Cleveland National Forest Power Line Replacement Projects

To: Lisa Orsaba, California Public Utilities Commission (CPUC); Allison Rice, Dudek
From: Kirstie Reynolds, San Diego Gas & Electric Company (SDG&E)
Date: May 7, 2020 (Revised May 29, 2020)
Re: Cleveland National Forest Power Line Replacement Projects, Phase II of Circuit 440
Minor Project Refinement Memo

ATTACHMENT A: C440 OVERVIEW COMPARE MAP

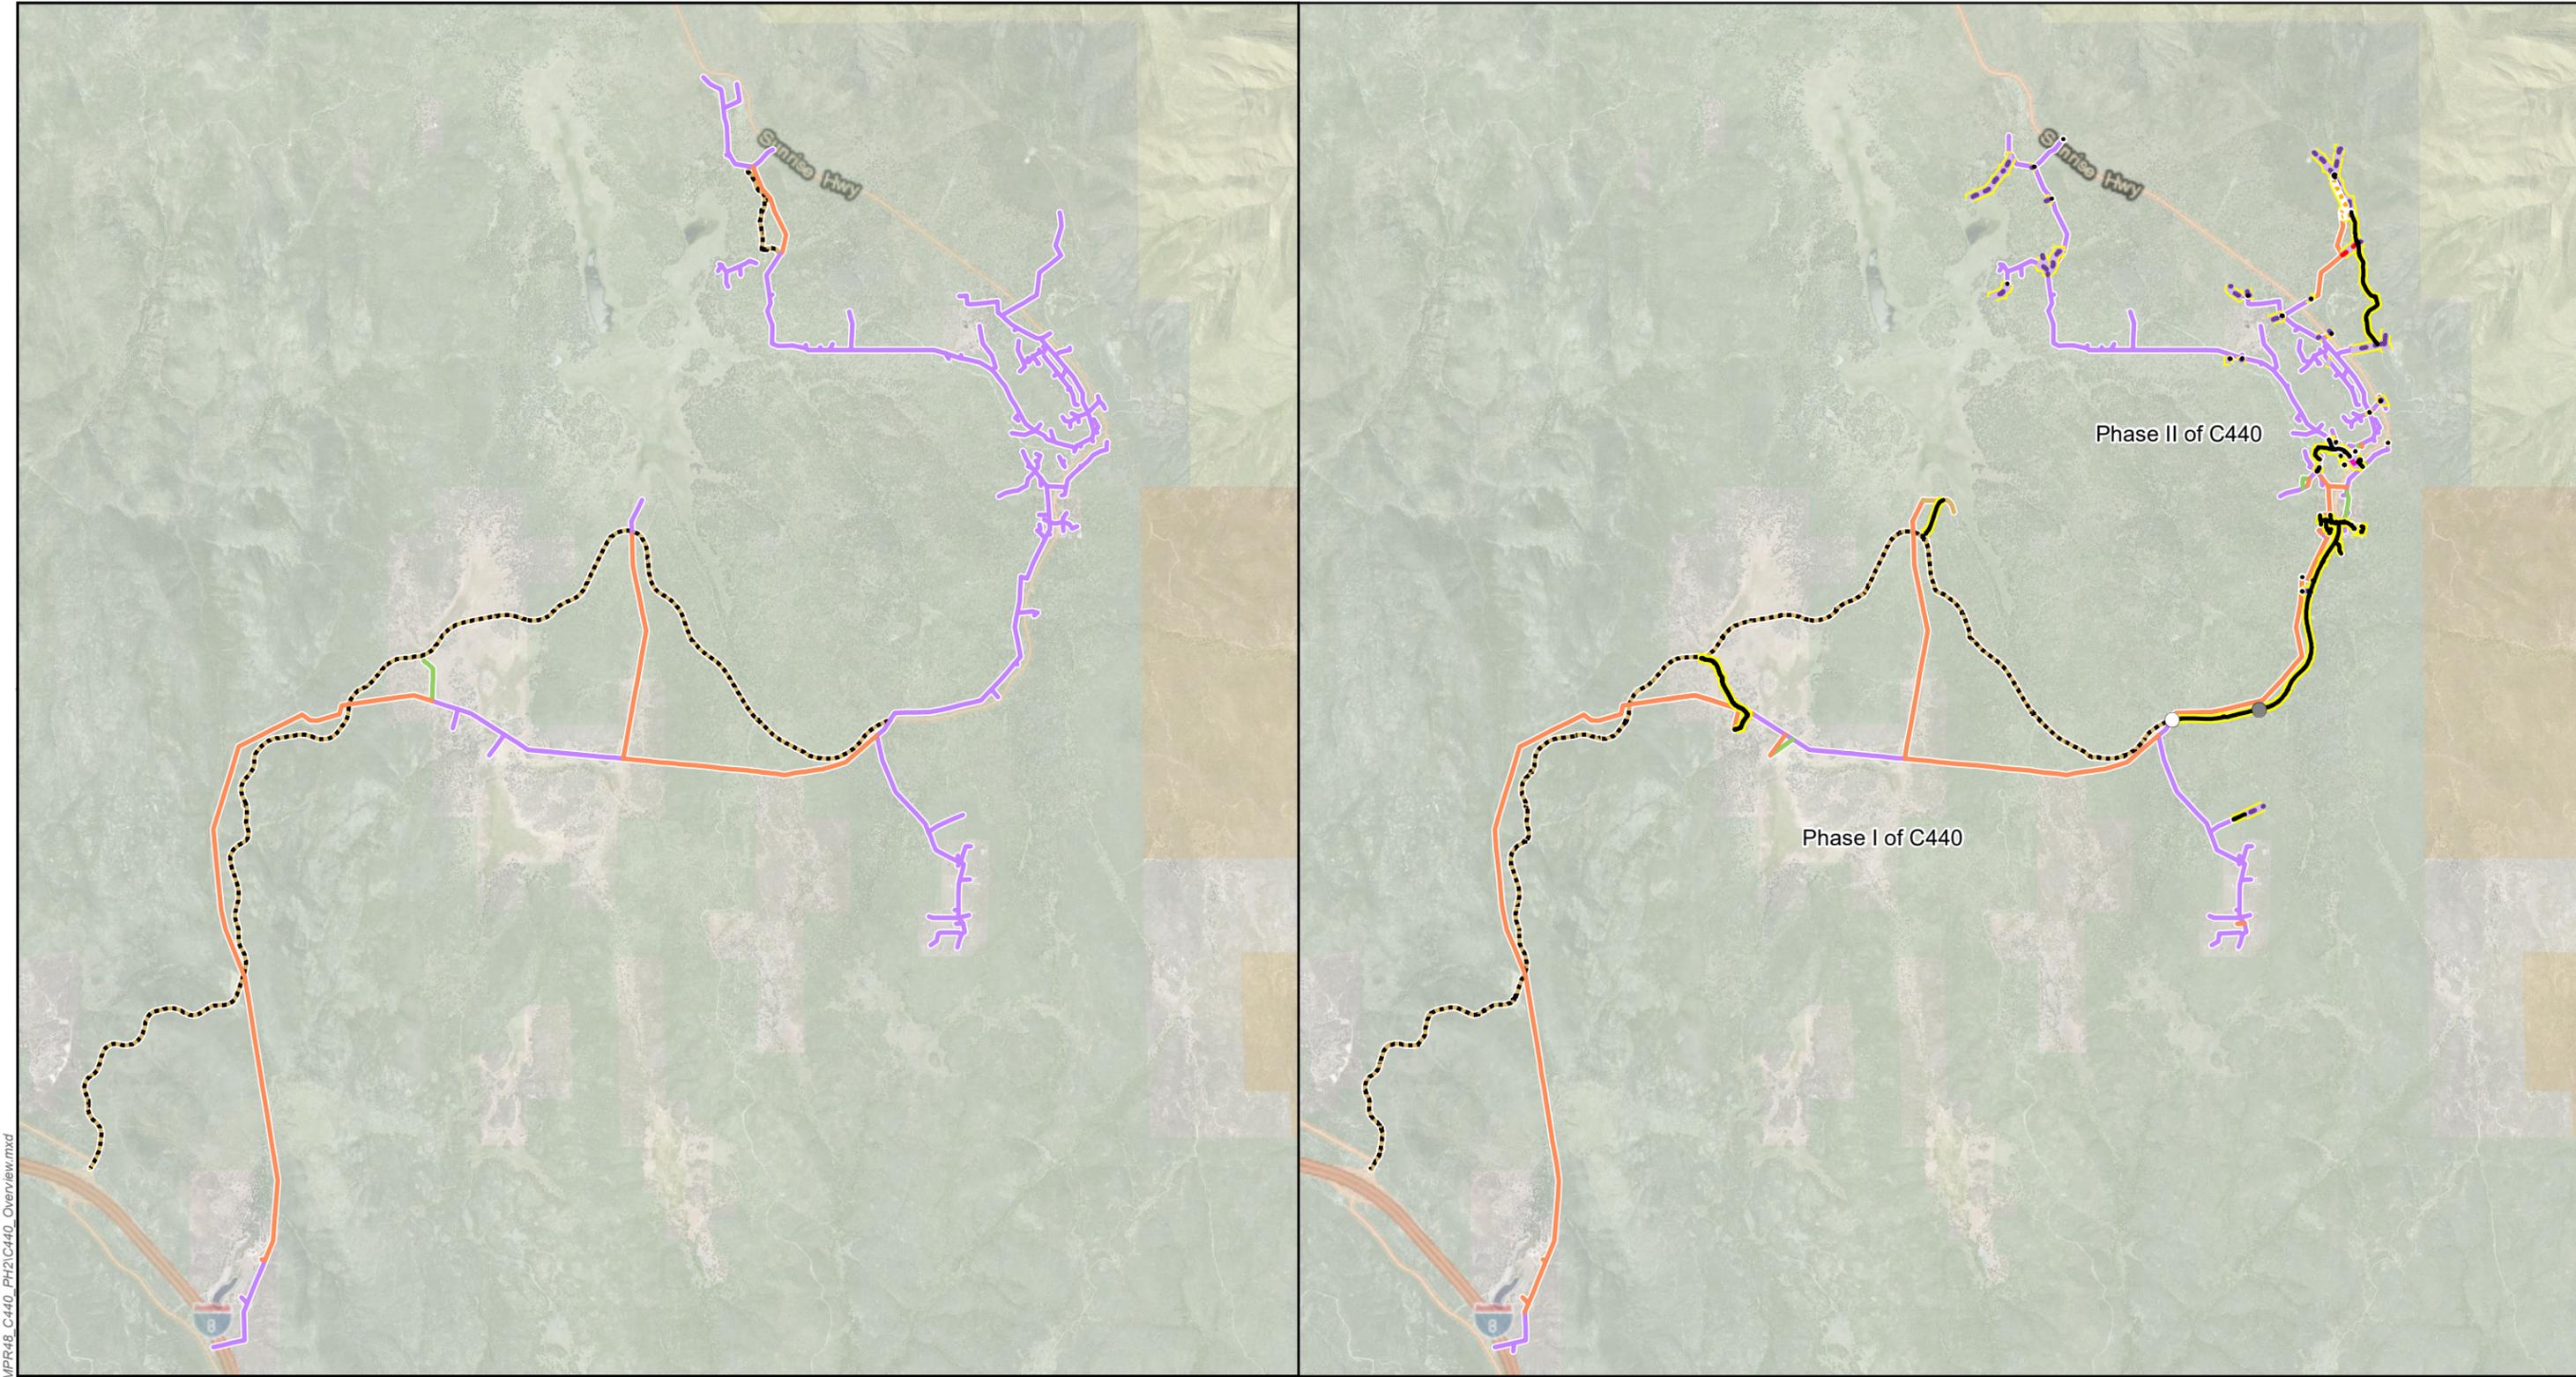
As a result, the final design for C440 includes in total approximately 14.1 miles of undergrounding analyzed as part of the Proposed Project, as well as considered in the Federal Preferred Alternative. A comparison of the Proposed Project to the final design for the entire C440 alignment is attached hereto at Attachment A: C440 Overview Compare Map.
